## Product Change Notice (PCN)

**PCN Number:** PCN-0455008R

Product(s) Affected: *PJ-036BH-SMT-TR*

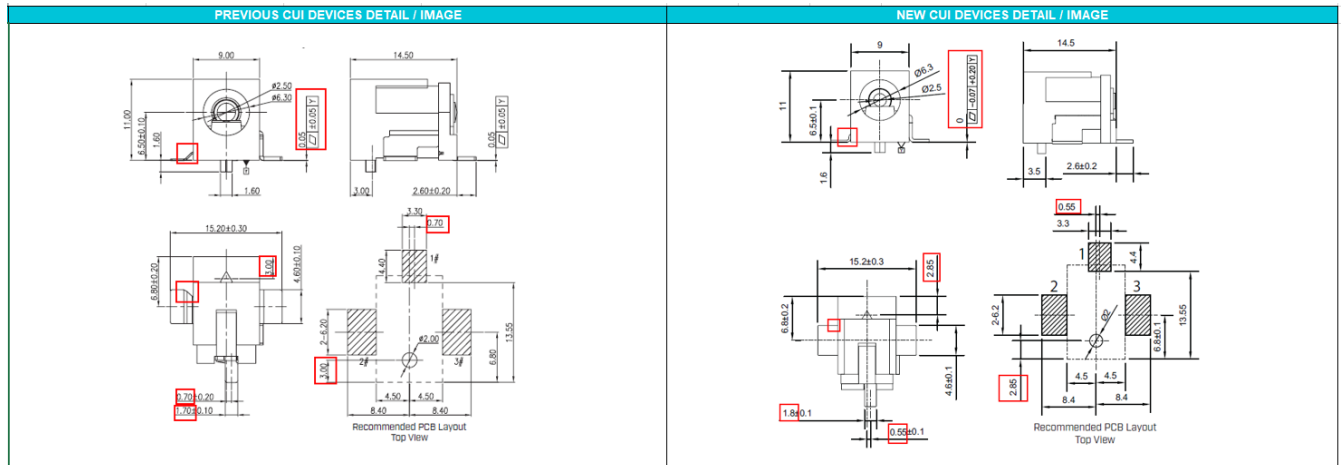
Description of Change: *Product re-engineered for improved manufacturability and production yield. Coplanarity specifications changed. Shape of terminal 2 changed. Location and size of terminal 1 changed. Locating post PCB hole location changed. See image below for reference and check CUI Devices website for updated drawing. Cosmetic differences may be visible and not affect the form fit and function of the product.*
